# Industry proposal

## False reaction scenario

AEBS-HDV-07

October 26-28, 2021

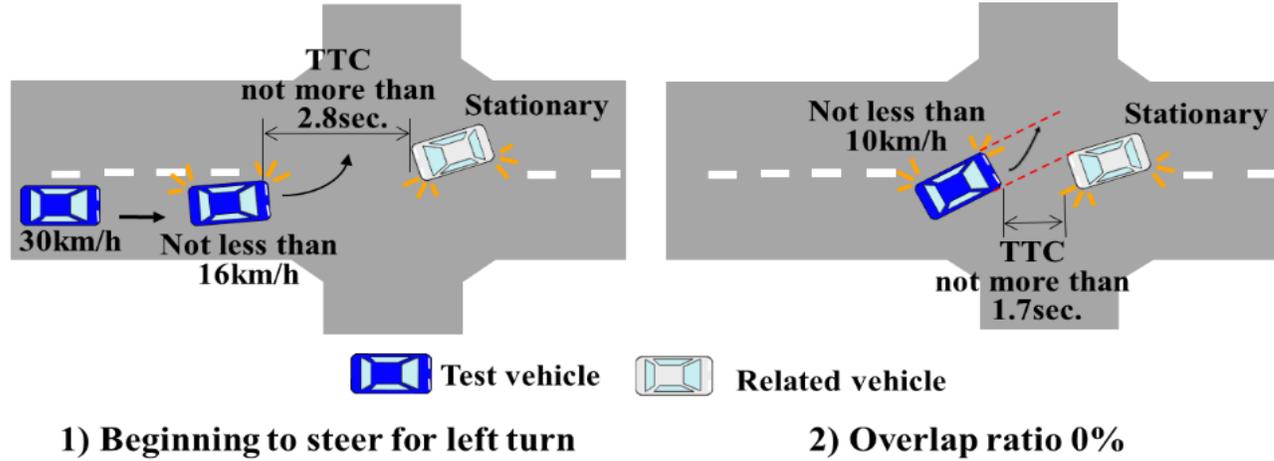
# Scenario 1 is not relevant for some HDVs (e.g. M3>8t, N2>8t N3)

(Furthermore, it looks not in accordance with driving licence rules in some countries).

Could this scenario be deleted for the heaviest categories?
